RENESAS TECHNICAL UPDATE

Product Category	MPU/MCU	Document No.	TN-R8C-A032B/E	Rev.	2.00
Title	Errata to notes of the port register		Information Category	Technical Notification	
Applicable Product	R8C/28 Group, R8C/29 Group	Lot No.	Reference Document

This document describes corrections to the port Pi register included in the following hardware manual.

Figure 7.7 Pi ($i = 1, 3, 4$) Register

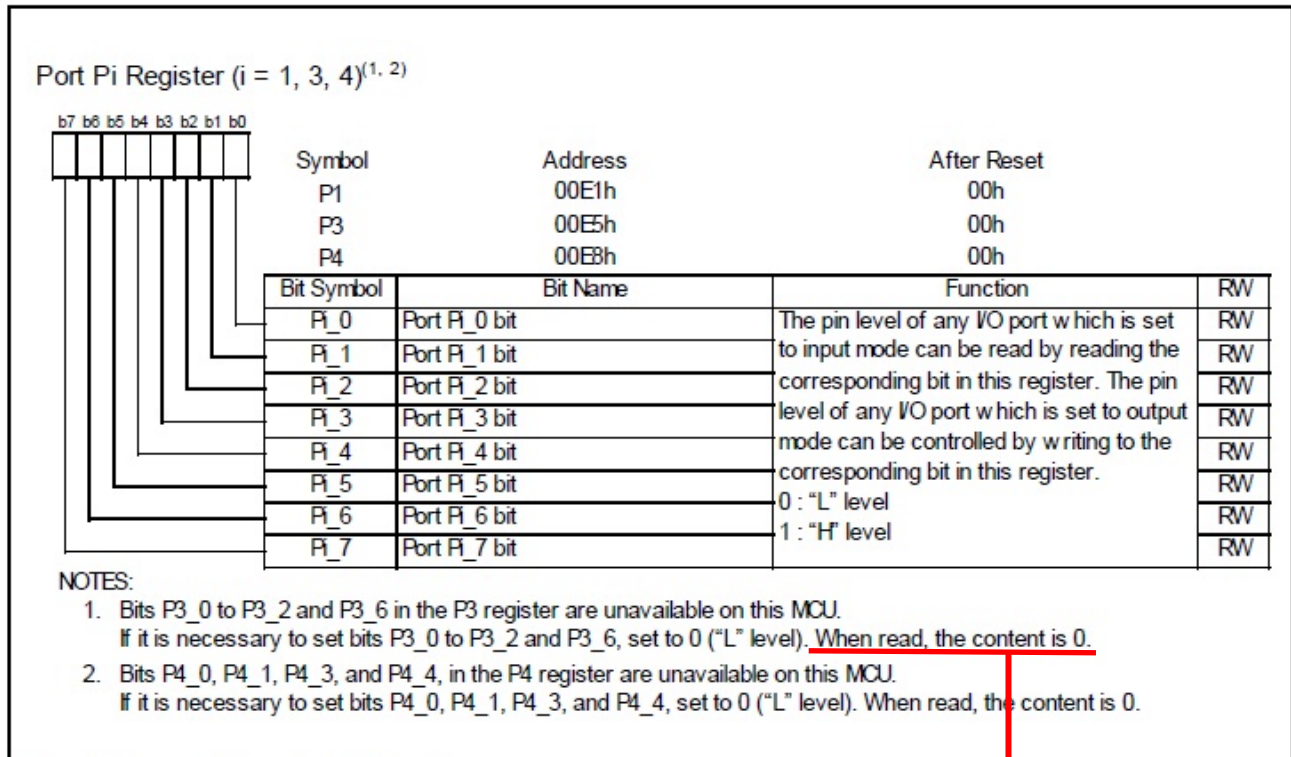
Applicable Products	Applicable Manual and Page	Applicable Ports
R8C/28 Group, R8C/29 Group	REJ09B0279-0210 (Rev.2.10), Page 57 of 441	P3_0 to P3_2, and P3_6

When read, the content is undefined.
